Hi-Fi Products
Service Bulletin

Model: CDP-C225 / C325 / C425

No. 319

Subject: Portions Of The Display Are Constantly Lit

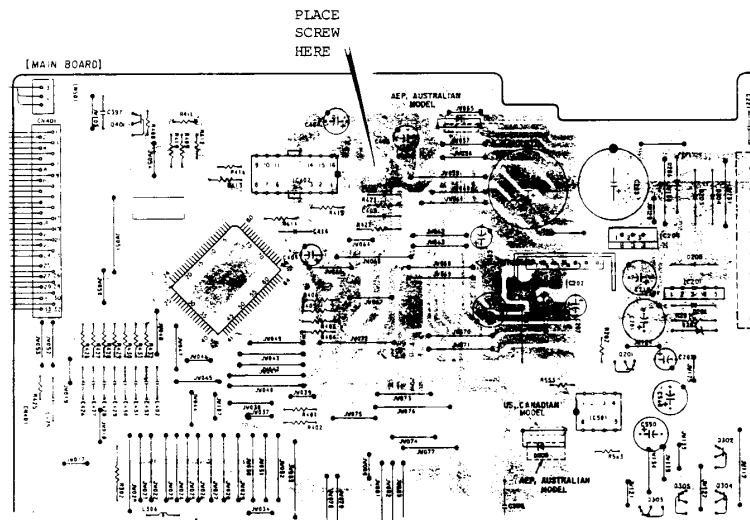
Portions of the display are constantly lit when the unit is powered on. The Main PC board becomes loose from the finger snap hold down which holds it to the chassis. This results in the Main PC board shorting to the bottom metal case which causes problems with the display.

Snap the Main PC board back onto the finger snap hold down and add a screw (type shown in the chart below) at the location shown in the drawing below.

DESCRIPTION	PART NUMBER
SCREW TAP +BV 3.0X8.0 BLK	7-685-646-79
